UNITED STATES PATENT AND TRADEMARK OFFICE

| APPLICATION NO. | FILING DATE | FIRST NAMED INVENTOR | ATTORNEY DOCKET NO. | CONFIRMATION NO. |
|-----------------|-------------|----------------------|---------------------|------------------|
| 10/607,679 | 06/26/2003 | Li-Peng Wang | 42.P16640 | 8027 |

Office Action Summary

DETAILED ACTION

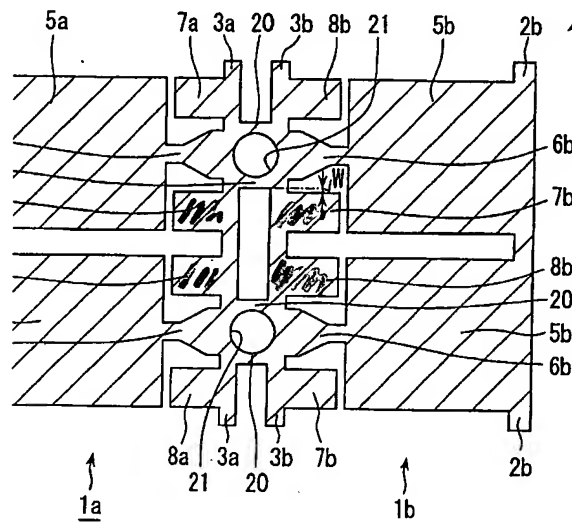
5. In response to applicant's argument that Kaneda fails to disclose the heat transfer layer surrounding, but not in contact with the electrodes, electrodes, it is shown in figure 9 a heat sink 5 (yellow) surrounding the electrodes 7a, 7b, 8a and 8b (green) as shown in the figure below.
